**REQUEST FOR INFORMATION**

Date of Decision: 18 Oct 2021  
Decision No: 1367  
Registered Reference: SD21A/0233  
Registration Date: 23 Aug 2021.  
Location: 1 Killakee Park Dublin D24 W9T2.

**Fig 1 & 2**  
[above]  
The existing houses at Killakee Park step relative to one-another creating a sawtooth stepped building line. Our proposal conforms to this morphology.

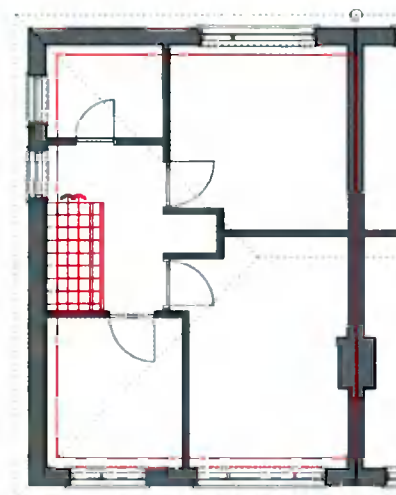
- c) At First floor level the house shall have a front-to-rear building depth that dose not exceed that of the existing house and other houses ion Killakee Park.**

- d) At ground floor level, a rear projection may extend the front to rear building depth beyond that outlined in (c).**

[below]  
Red outline indicates the reduction in floor area relative to the increase in the thickness of the thermal envelope to comply with contemporary standards and future proof a house based on the existing front to back building line.

Our proposal conforms to the stepped building line at Killakee Park. Each pair of houses steps relative to its neighbour as the street progresses from east to west towards the park. Other streets in this area follow a similar morphology. The final house, at each street, steps and is sometimes twisted relative to its neighbours. We have stepped our proposal in line with this context but also twisted the house so it addresses equally the park and the street in line with the dual frontage requirement at section 11.3.2 (ii) Corner development should provide a dual frontage in order to avoid blank facades and maximise passive surveillance of the public domain.

**Fig 6 & 7.**  
 [above]  
 Option B which retains the existing street, Lime, tree moves the entrance closer than necessary to the junction.  
 [below]  
 Option A with proposed location of replacement tree and the safer entrance to the proposed new house approved by traffic.

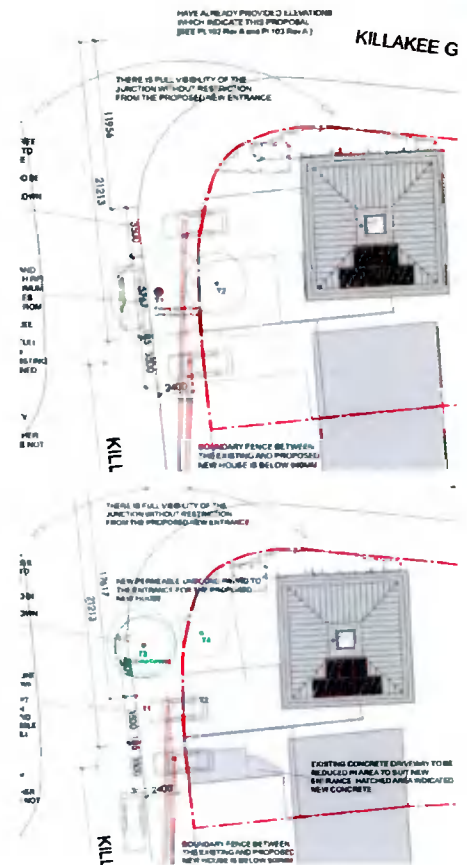
(i) Relocated one or both of the proposed vehicular accesses to as not interfere with the Root Protection Area of the existing tree, Limit the width of each vehicular access point to 3.5m and if possible provide enough separation to allow on street car parking between the accesses.

(ii) If assessment of alternatives under (i) shows there to be no safe alternative to the proposed layout, the applicant will show where a replacement tree would be planted , in the public realm, at the applicant's expense. Assessment under (i) should be demonstrated in this case.

Two options for the entrance locations were provided to the Traffic Department; one which preserves the tree but places the entrance of the new house closer to the junction and another which removes the tree locating the entrance for the new house further from the entrance.

The option which retains the street tree places the entrance within 11.95m of the junction. Option A which removes the tree is 17.61m from the junction and provides a safer entrance with better sight lines. We presented both to traffic and they have accepted that the option which removes the tree is an appropriate and acceptable solution.
